Access Compliance Report

Public Rights-of-Way

Intersection ID: 10020954	Main Street: BENNETT_WOODS_CT	Cross Street: N/A	Location: NE
ADA ID: 537FE20FC8D8	Ramp Type: Perp	Initial Pass/Fail: Fail	Overall Compliance: No
Severity Score: 25			
Codes/Mitigation Info/Possible Solution		Field Measurements/Component Compliance

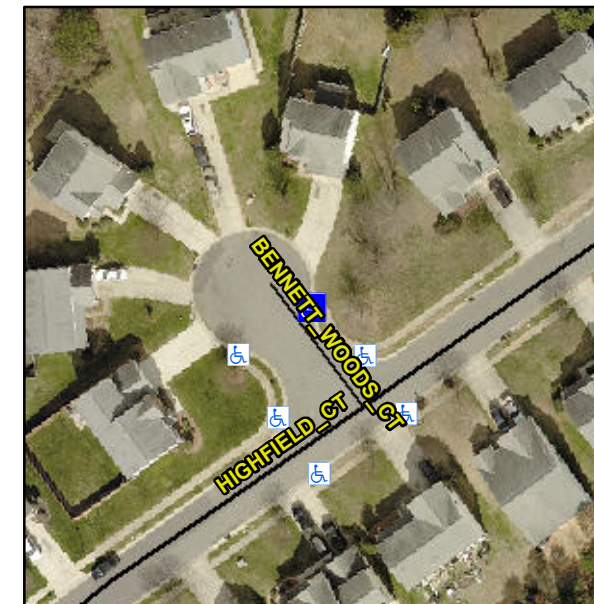
Not Found, R304.2.2

Compliance	Description	Data	Compliance	Description	Data
N/A	Ramp Length (in)	39.5	No	Ramp Slope (%)	12.0
Yes	Ramp Width (in)	48.0	Yes	Ramp XSlope (%)	1.0
N/A	Flare Type LT	N/A	N/A	Flare Type RT	N/A
N/A	Flare Slope LT (%)	N/A	N/A	Flare Slope RT (%)	N/A
N/A	Flare Traversable LT?	N/A	N/A	Flare Traversable RT?	N/A
N/A	Landing Length (in)	N/A	N/A	DWS Provided?	N/A
N/A	Landing Width (in)	N/A	N/A	DWS Contrast?	N/A
N/A	Landing Slope (%)	N/A	N/A	DWS Length (in)	N/A
N/A	Landing X Slope (%)	N/A	N/A	DWS Full Width?	N/A
N/A	Landing Curb? (Y/N)	N/A	N/A	DWS Offset (in)	N/A
N/A	Shared Landing?	N/A			
N/A	Gutter Ponding?	N/A	N/A	Gutter Slope (%)	N/A
N/A	Gutter Lip Ht (in)	N/A	N/A	Gutter X Slope (%)	N/A
N/A	Painted X Walk1?	No	N/A	Painted X Walk2?	N/A
	X Walk 1 Direction	To W		X Walk 2 Direction	N/A
N/A	X Walk 1 Width (in)	N/A	N/A	X Walk 2 Width (in)	N/A
	X Walk 1 Slope (%)	2.5		X Walk 2 Slope (%)	N/A
	X Walk 1 X Slope (%)	3.3		X Walk 2 X Slope (%)	N/A

Remove & Replace Entire Ramp.
